Access Compliance Report

Public Rights-of-Way

Intersection ID: 8120	Main Street: INGLE_ST	Cross Street: TENNESSEE_AV	Location: SW
ADA ID: 9D99B6556A79	Ramp Type: Perp	Initial Pass/Fail: Fail	Overall Compliance: No
		Severity Score: 25

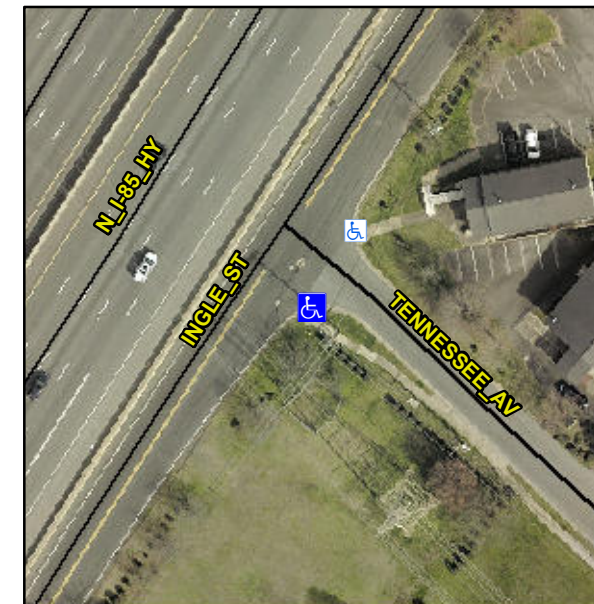
Not Found, R304.5.3

Compliance	Description	Data	Compliance	Description	Data
N/A	Ramp Length (in)	78.0	Yes	Ramp Slope (%)	6.5
Yes	Ramp Width (in)	48.2	No	Ramp XSlope (%)	9.5
N/A	Flare Type LT	N/A	N/A	Flare Type RT	N/A
N/A	Flare Slope LT (%)	N/A	N/A	Flare Slope RT (%)	N/A
N/A	Flare Traversable LT?	N/A	N/A	Flare Traversable RT?	N/A
N/A	Landing Length (in)	N/A	N/A	DWS Provided?	N/A
N/A	Landing Width (in)	N/A	N/A	DWS Contrast?	N/A
N/A	Landing Slope (%)	N/A	N/A	DWS Length (in)	N/A
N/A	Landing X Slope (%)	N/A	N/A	DWS Full Width?	N/A
N/A	Landing Curb? (Y/N)	N/A	N/A	DWS Offset (in)	N/A
N/A	Shared Landing?	N/A			
N/A	Gutter Ponding?	N/A	N/A	Gutter Slope (%)	N/A
N/A	Gutter Lip Ht (in)	N/A	N/A	Gutter X Slope (%)	N/A
N/A	Painted X Walk1?	No	N/A	Painted X Walk2?	N/A
	X Walk 1 Direction	To NE		X Walk 2 Direction	N/A
N/A	X Walk 1 Width (in)	N/A	N/A	X Walk 2 Width (in)	N/A
	X Walk 1 Slope (%)	0.9		X Walk 2 Slope (%)	N/A
	X Walk 1 X Slope (%)	3.1		X Walk 2 X Slope (%)	N/A

Remove & Replace Entire Ramp.
